**CITY OF PLANT CITY
Purchasing Department
(813) 659-4270**

ADDENDUM 1

**IFB 16-025UM-DB
Manhole Replacement and Line Extension at Grant and Hunter St**

IFB 16-025UM-DB
ADDENDUM 1
ATTACHMENT A

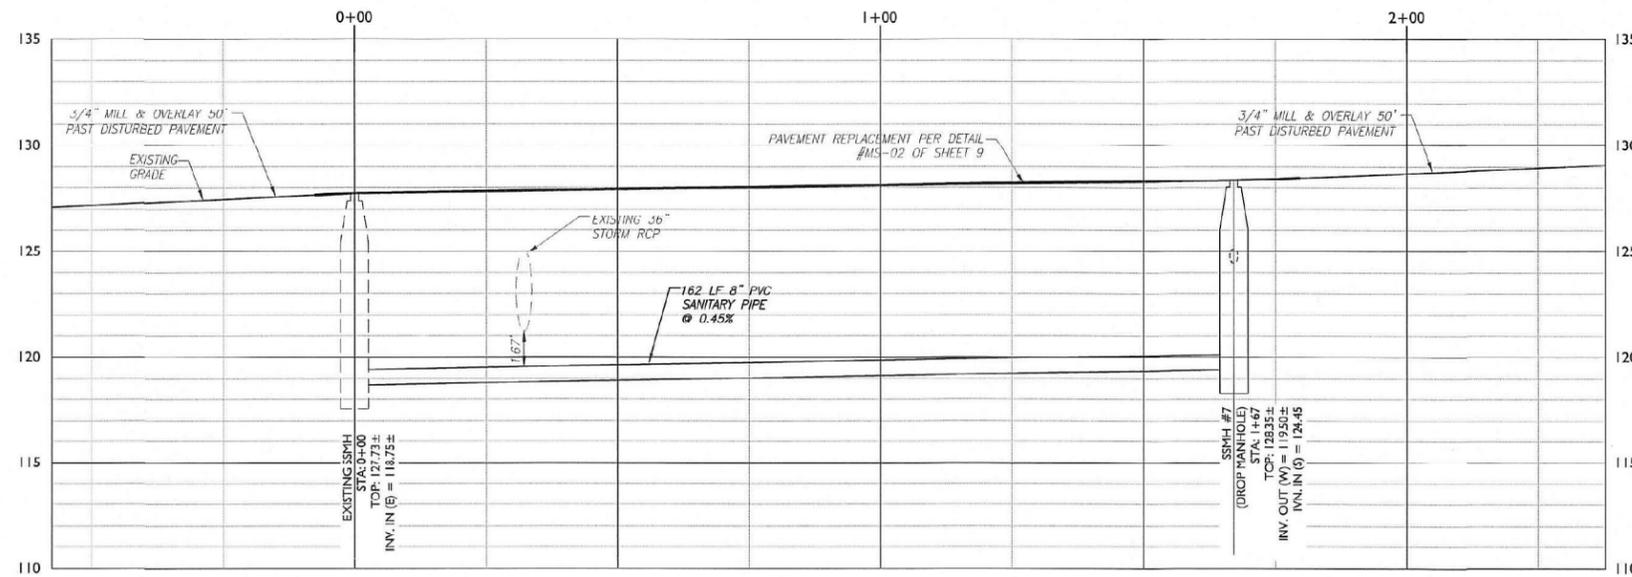
Q. Where is the new 75 LF of 8" Sewer Main to be installed?

A. The new 8" main will be installed on the east side of the replaced manhole and run due east (under the existing 36" RCP storm pipe, see Attachment A).

IFB 16-025UM-DB
ADDENDUM 1
ATTACHMENT B

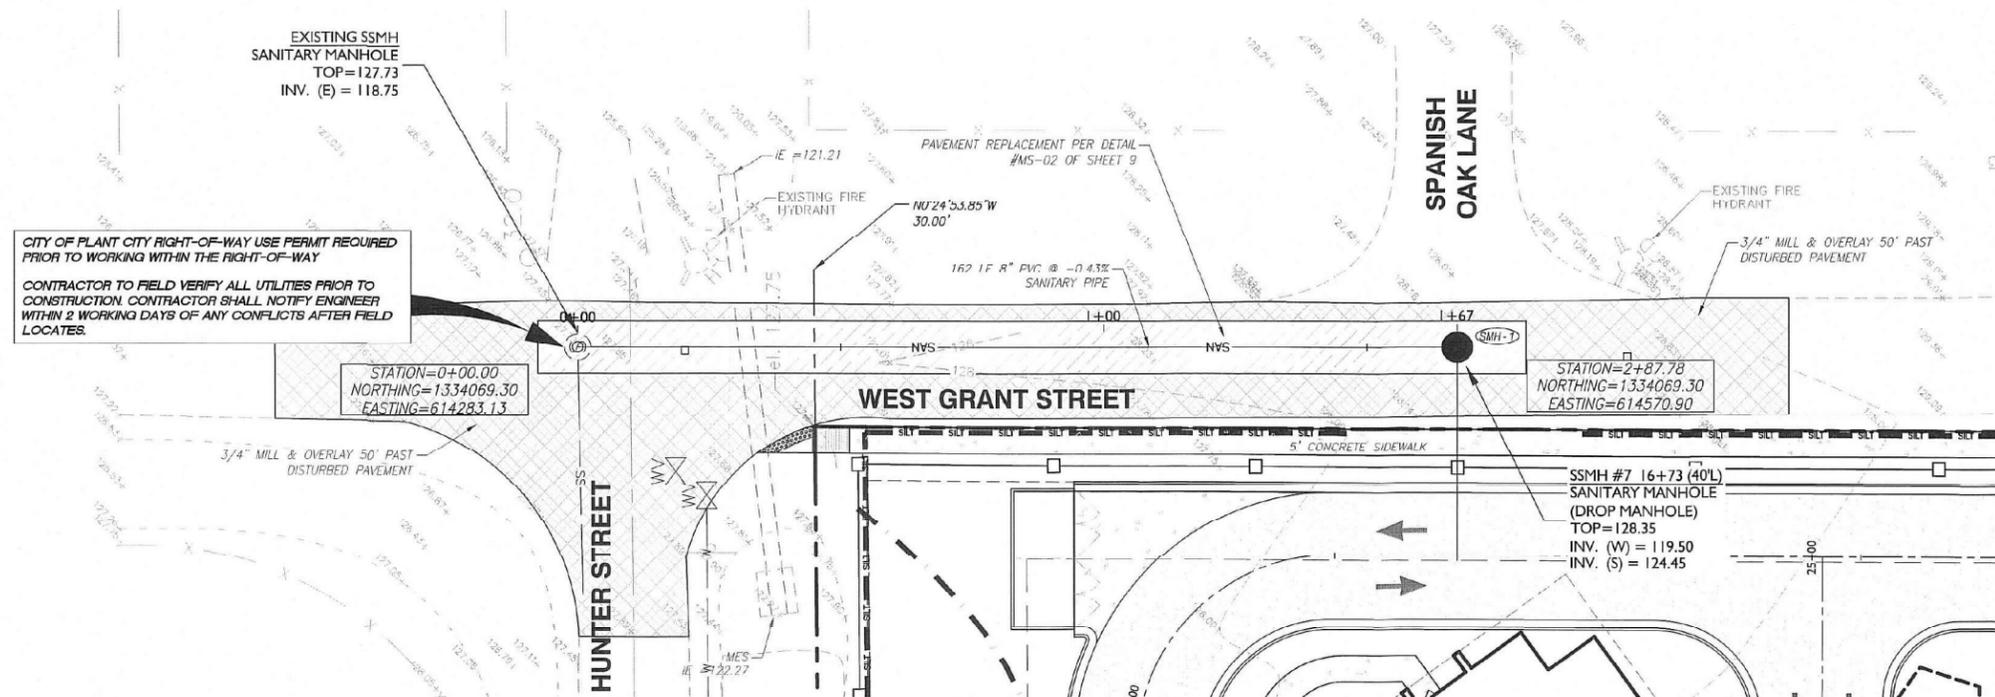
Q. Which direction does the 24" Force Main flow? And where are the existing manholes on each side of the one to be replaced located?

A. The 24" main is gravity.

The upstream manhole (4-990) is approximately 2172 linear feet north of the manhole to be replaced

The downstream manhole (4-988) is 391 west of the manhole to be replaced.

(see Attachment B)

The size of the main running from MH 4-990 to MH 4-989 is 24"
